Solution

Title (customer effect)	Automated Manual Transmission (AMT) Power Take-Off (PTO) Solenoid Bracket Modification For Dual PTO Solenoids
-------------------------	---

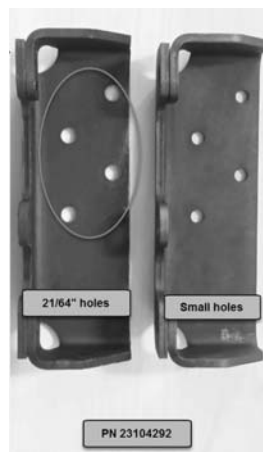
Solution	The four mounting holes in the bracket are too far apart to allow two solenoids to be bolted to the bracket properly. Single PTO solenoid installations are ok. If a unit that is built with bracket Part Number 23104292 and a single PTO solenoid setup is modified to be a dual PTO setup, the mounting holes in the bracket must be drilled out to allow the bolts to line up.
----------	--

Drill the 4 mounting holes out to 21/64" to allow for bolt alignment. See the image below.

The new bracket, Part Number 23220187, will have the hole locations corrected and will not require modification to mount dual PTO solenoids.
